# SERVICE BULLETIN

**Subject:** Liberated Head of Tubular Rivet PN 800162WE, installed in JT8D Engine 7<sup>th</sup> Stage High Pressure Compressor (HPC), (reference SIL 130418-001, dated 4/18/2013).

Service Bulletin No: 130617-001  
 Page 1 of 4

**Figure 1, Rivet ISO View & Section View of Installed Rivet**

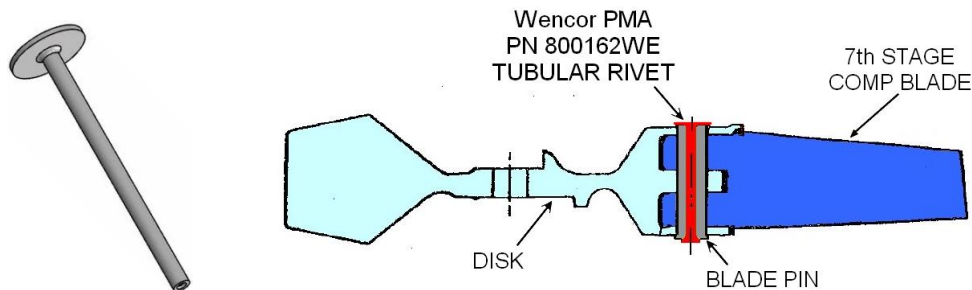
Between January and July 2013, two customers have discovered a total of 13 Wencor Tubular Rivets that had liberated the rivet head after an unknown time in service. The rivets were installed in the 7<sup>th</sup> stage HPC section of JT8D series engines, and were assembled between January 2011 thru December 2011. On 9 engines a single rivet head out of 60 total rivets was found missing and on 2 engines two rivet heads were found missing. No engine related failures or detectable loss of performance in engine operation has been caused by the failed (liberated head) rivets at any customer.

**Figure 2:** Wencor Rivets with Marking on Rivet Head

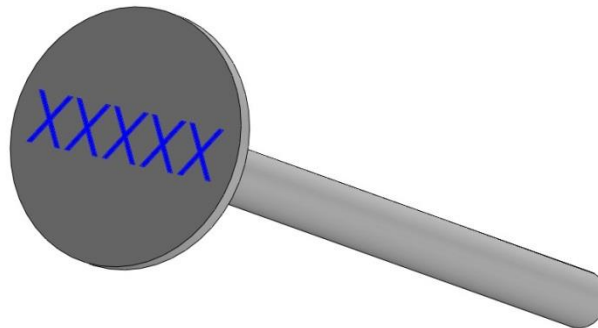
The repetitive borescope inspection may cease when all Wencor rivets that do not have any marking on the rivet head as shown below in Figure 2 have been removed from service. Rivets with marking on the rivet head have been inspected for cracks under the rivet head and screened for proper manufacturing.
